DESCRIPTIVE REPORT

Field No. H11839 _____

General Locality _____ Northern Cook Inlet _____

Sublocality: **Beluga Shoal**

Figure 4 – Item 1: Charted wellhead with multibeam and sidescan sonar coverage

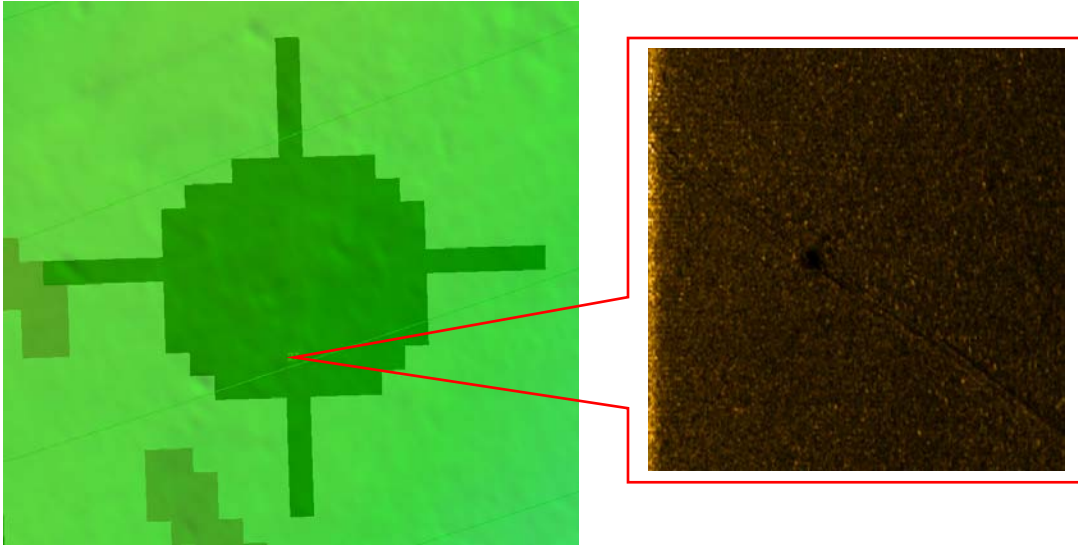
1. Charted Wellhead “cov 14 fms” (chart 16663) at 61-03-34.70N, 150-55-09.60W was confirmed by this survey (survey position 61-03-33.90N, 150-55-08.75W) with complete multibeam coverage and 100% sidescan (SSS contact 198 - 171712S). Survey position is approximately 25 meters south of charted position. Survey least depth was 26.916 meters (14 fathoms). Recommend updating feature to survey position. Recommend updating AWOIS database (record ID 52421) with survey data. ***Concur with clarification. Delete charted feature and add survey feature at the survey position.***

Figure 5 – Contours from H11839 (purple) overlaid on chart 16663

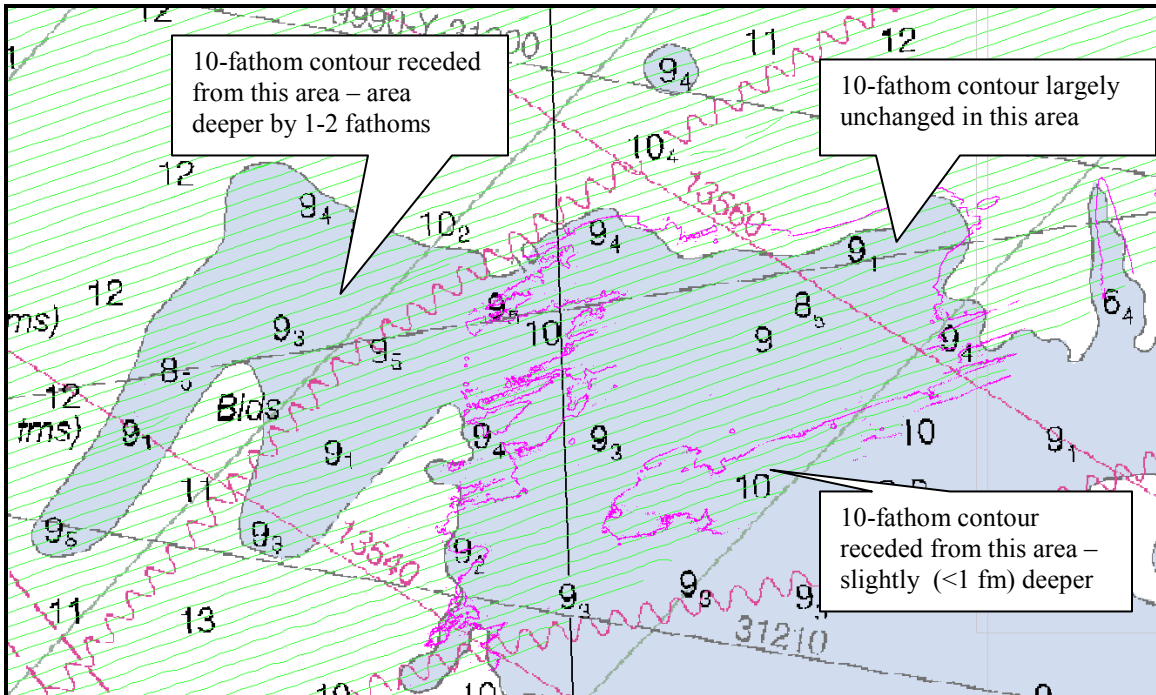
1. 10 fathom (60 foot) contour in the southwest part of the survey area has receded on its western half, with the area deepening by an average of 1 fathom. **Concur**

Figure 6 – Beluga Shoal: Contours from H11839 (purple) overlaid on chart 16665

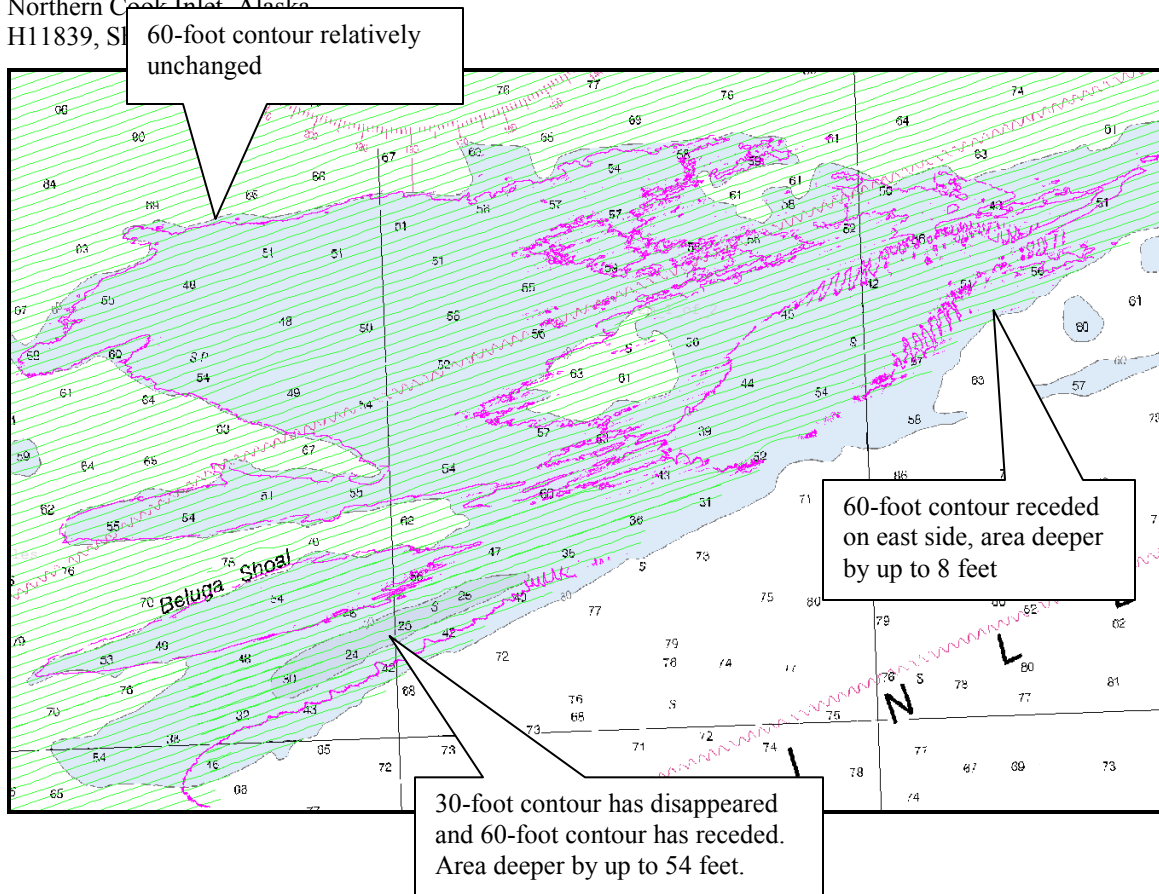
2. Beluga shoal has dramatically deepened on its south side; shifting the 60-foot contour there and removing the 30-foot contour altogether, while the north side has remained relatively unchanged. The 60-foot contour has also receded on its eastern side. **Concur**

Of particular note is the area within the charted 30-foot contour on the south side of Beluga Shoal; the area is charted with least depths of 24-30 feet while this survey found depths of 62-78 feet -- a deepening of 32 to 54 feet. **Concur**

Figure 7 –Contours from H11839 (purple) overlaid on chart 16665. DTON soundings are red.

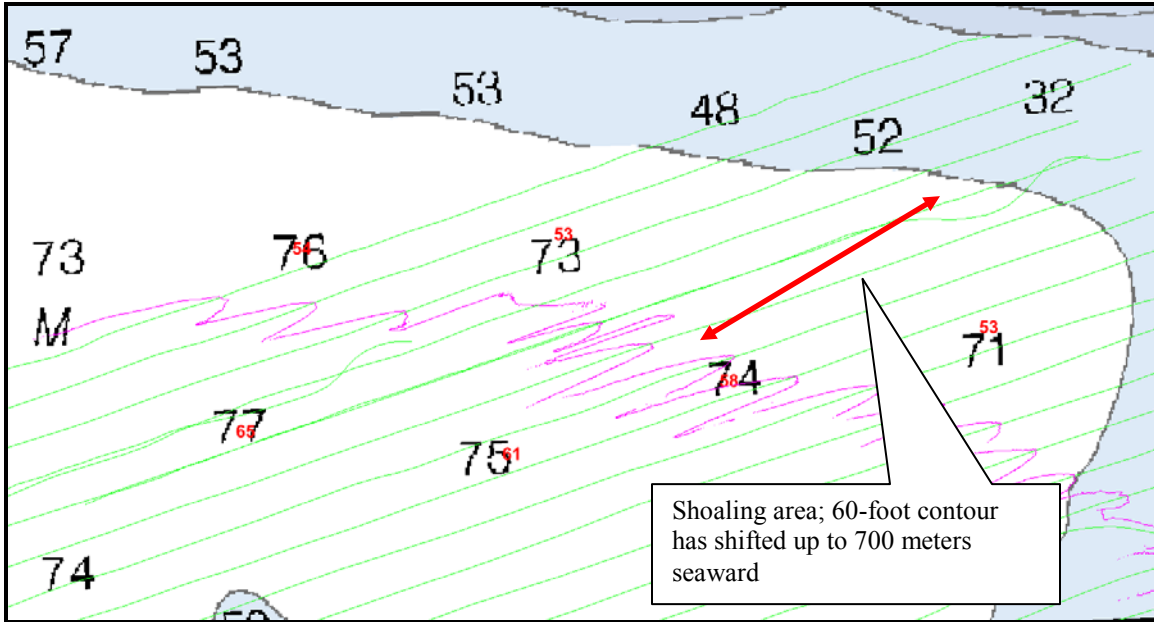
3. The northeastern corner of the survey area has shoaled by up to 20 feet, with the 60-foot contour shifting approximately 700 meters further seaward. **Concur**

Soundings in this area were reported as a D TON t o A HB on 10/ 22/09 (OPR_P385_TE_08_H11839 DtonReport_11). **Concur**

Figure 8 – Item 2: Charted wellhead with multibeam and sidescan sonar coverage

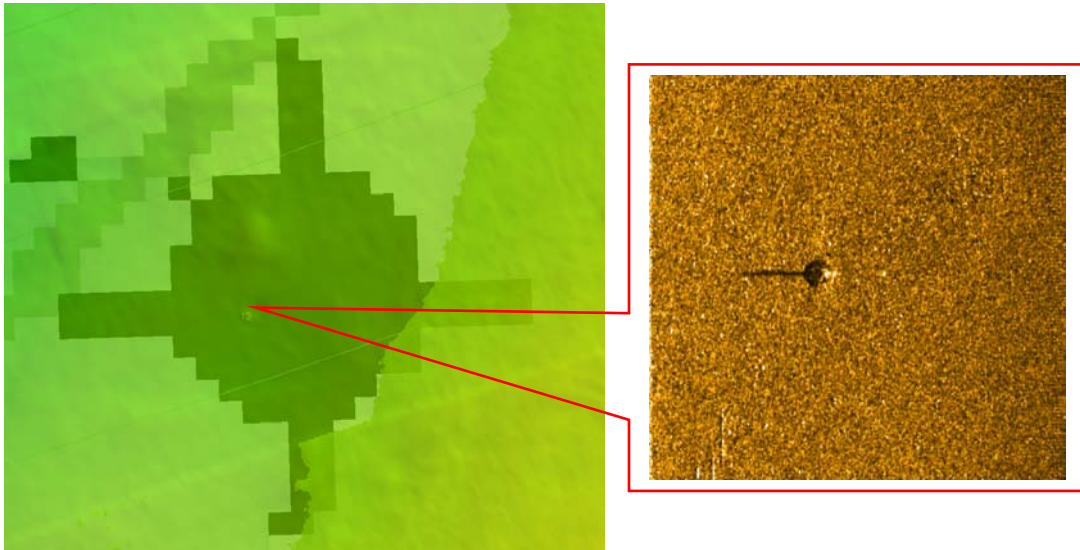
1. PA Obstruction feature “Pipe rep Subm approx 0₁ fm at MHHW” on chart 16663 at 61-06-09.60N, 150-55-07.77W was not found by this survey. The area received 100% multibeam and sidescan coverage with no indication of features or obstructions in the area. Recommend removal. **Concur**
2. PA Wellhead feature “rep cov 8 fms 1 ft” on chart 16663 at 61-06-11.28N, 150-55-00.46W was confirmed by this survey, with a slightly different position and depth. The area received 100% multibeam and sidescan coverage and a wellhead-like contact (SSS feature 194-090547P, height off seafloor of 4.328 meters) was detected at 61-06-11.01N, 150-55-02.13W with a multibeam least depth of 23.487 meters (12 fathoms). **Concur with clarification. Delete charted feature and add survey feature at the survey position.**

Recommend updating to survey position. Recommend removal of “PA” text from chart and recommend “rep cov 8 fms 1 ft” be retained as it is possible multibeam did not capture the least depth over the feature. **Concur**

Figure 9 – Item 4: Charted wellhead with multibeam and sidescan sonar coverage

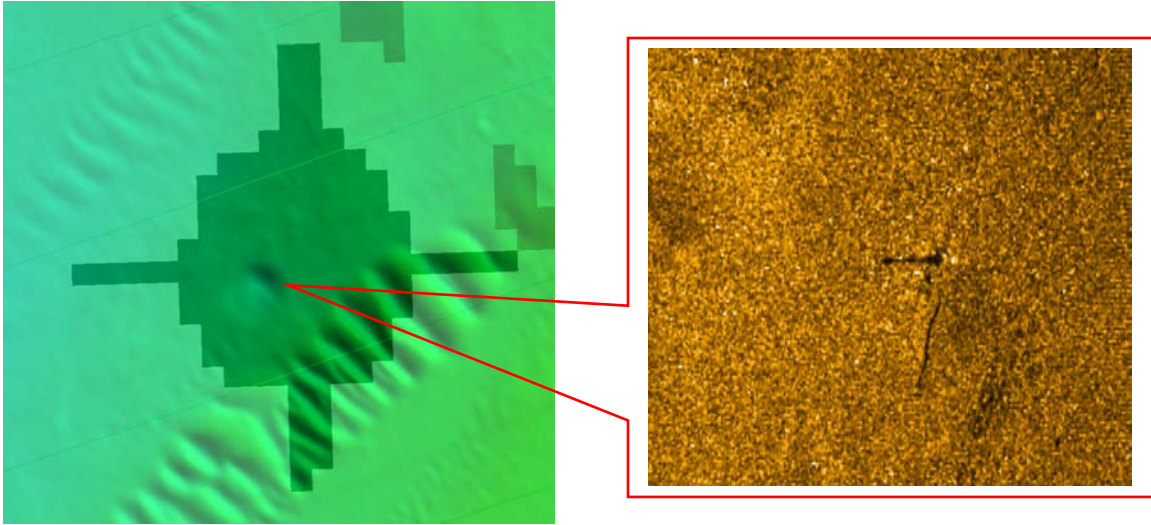
4. PA Wellhead feature “rep cov 17 fms” on chart 16663 at 61-04-07.20N, 150-56-41.64W was confirmed by this survey. The area received 100% multibeam and sidescan coverage. Sidescan records (contact 197-085202P) indicate a wellhead-like feature at 61-04-07.05N, 150-56-42.20W (height off seafloor 3.516 meters). Multibeam acquired no hits on the contact but did indicate scour in the area. Least depth from sidescan sonar is 28.184 meters (15 fathoms). Recommend updating to surveyed position and depth. **Concur with clarification. Side scan does display a contact at the survey position, and the multibeam data only indicates a scour at the survey position. See SAR Additional Verification Notes section. Retain as charted.**

Recommend removal of “PA” and “rep” text from chart. **See above.**

2. Processing Workflow Flowchart Technical Note

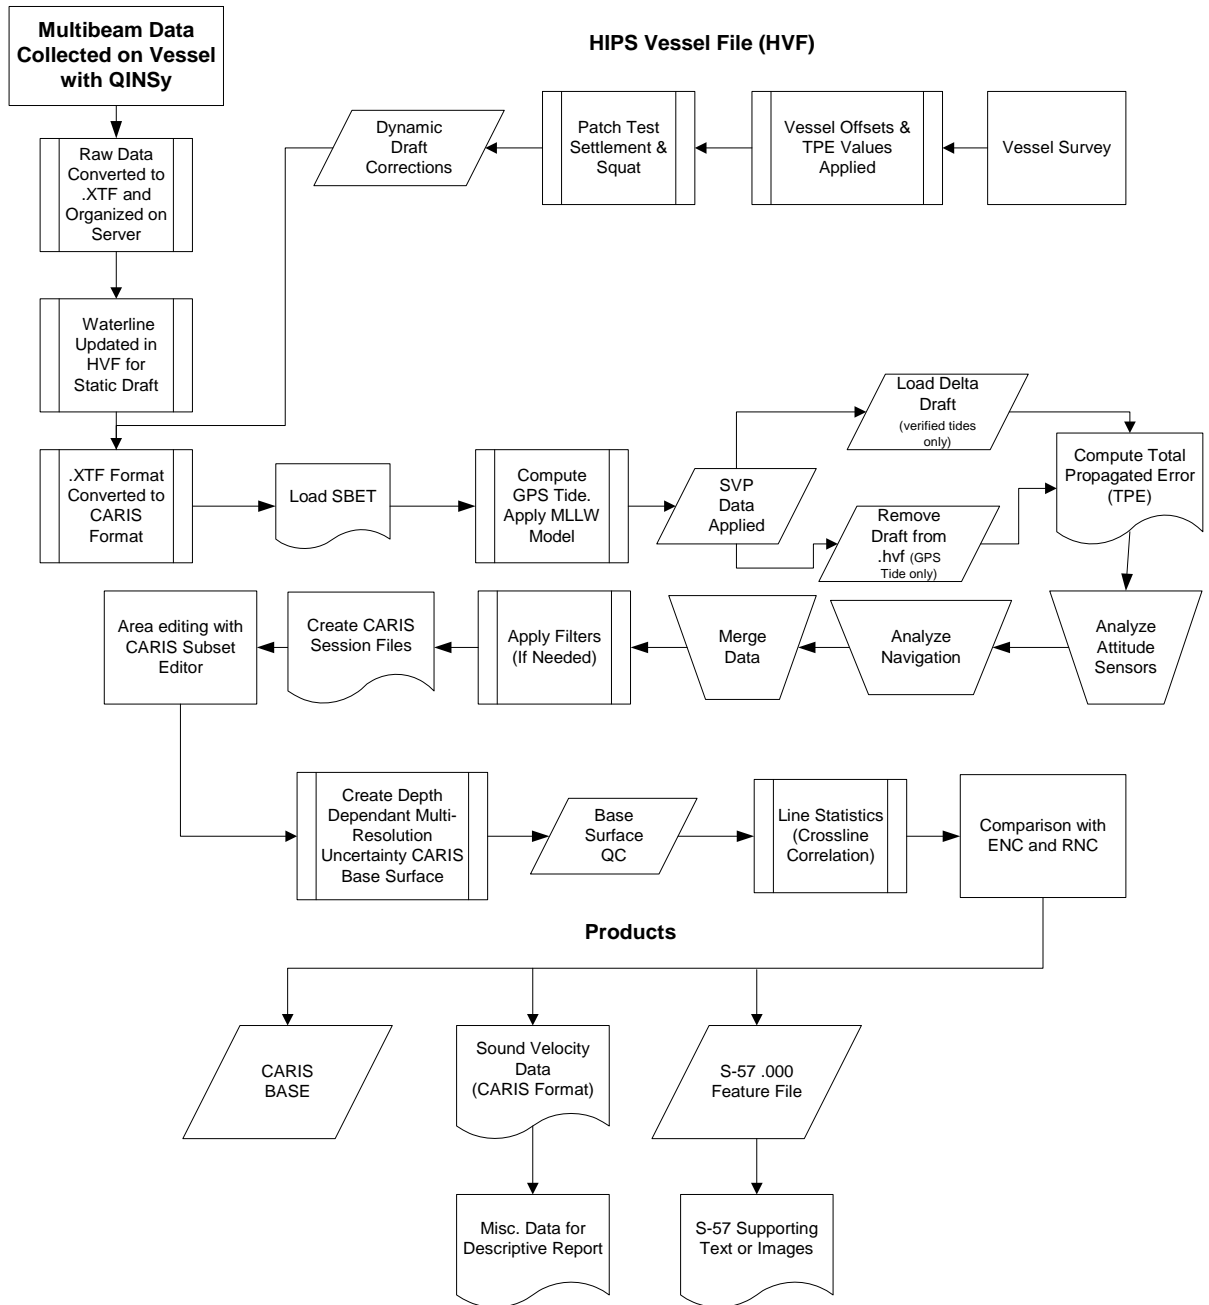
DAPR Section B.6 Field Data Processing (pg. 20) data acquisition and reduction flowchart needs to be amended to reflect the removal of speed-based dynamic draft values from the vessel file associated with survey lines processed with PPK-based GPS tide and the loading of rpm-based delta draft values for those lines processed with verified tides and zones.

The following diagram should replace *DAPR Section B.6 Field Data Processing (pg. 20)*:
